Our reference 22-312-20

RE: CALTHORPE STREET, BANBURY – LETTER OF RESPONSE

I am writing further to your Authority's comments dated 19th July 2023 in respect of planning application 23/01633/F, which seeks permission for the redevelopment of retail units & public car park into residential dwellings.

Town Houses

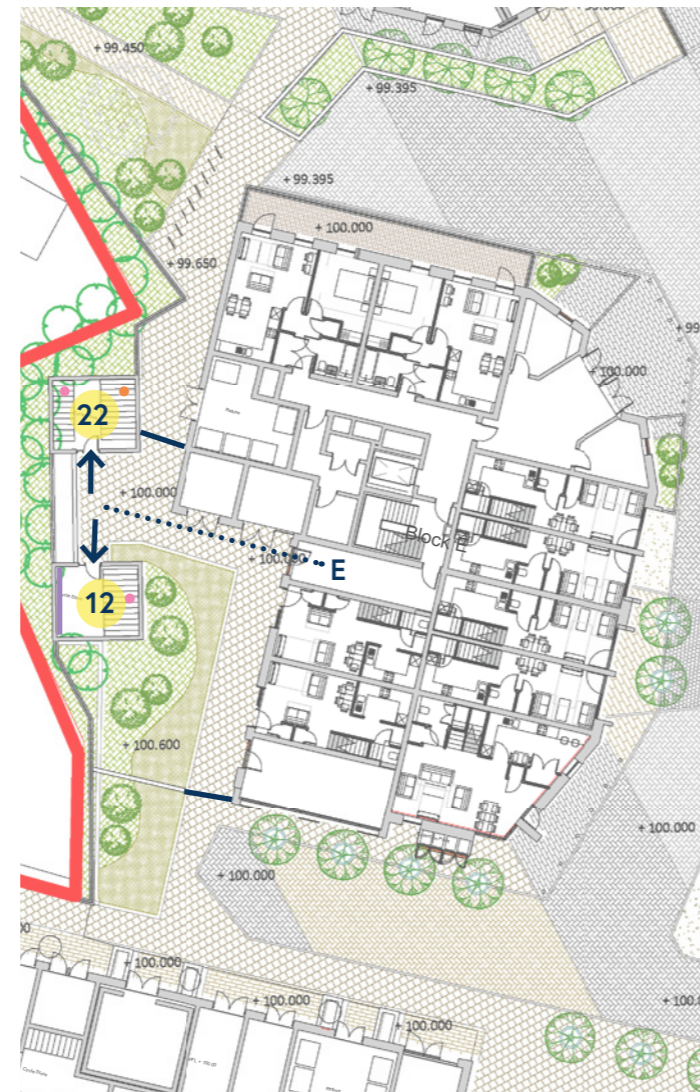
“Covered cycle parking for the townhouses is absent from the plans and should be included.”

We have sought to provide clarity on the location and type of provision in line with comments. With this, Section 1.4 (page 9) of the appended Accessibility Report outlines that cycle parking for the townhouses will be provided as covered, secured parking within the rear gardens. Each property will be able to access the rear garden separately from the house.

1.5 Cycle Hire Lockers

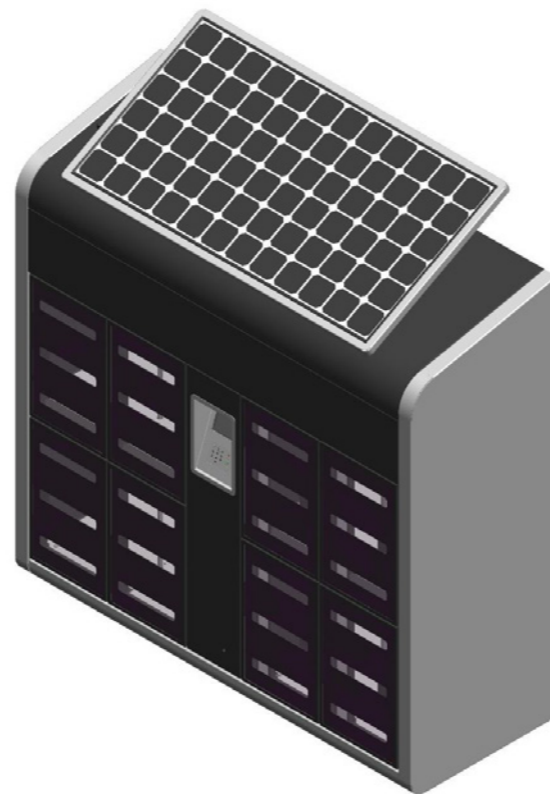
“The TA states that cycle parking would be provided at one space for a 1-bedroom unit, and 2 spaces for larger units. However, since our preapplication advice the parking standards have been updated. The requirement is now for 2 spaces per bedroom.”

A better of way dealing with this would be to provide a form of on demand cycle provision, such as, a Brompton bike hire vending machine. This would avoid the need to provide cycle parking for the infrequent and mostly leisure-based trip purposes. This was discussed at the meeting with OCC (dated 23rd August 2023), where there was broad agreement. This has now been discussed with the applicant, with agreement to provide the Brompton machine in the centralised and highly visible location shown within Section 1.5 of the appended Accessibility Report.

As suggested by OCC, the Travel Plan Coordinator will monitor demand via Brompton's usage statistics – which are recorded at each locker location. As such, the requirement for further spaces can be determined. Alongside this, OCC requested that we identify the potential locations for an additional locker within the site. In this way, Section 1.5 (page 12) of the appended report outlines an additional location within the centre of the site.
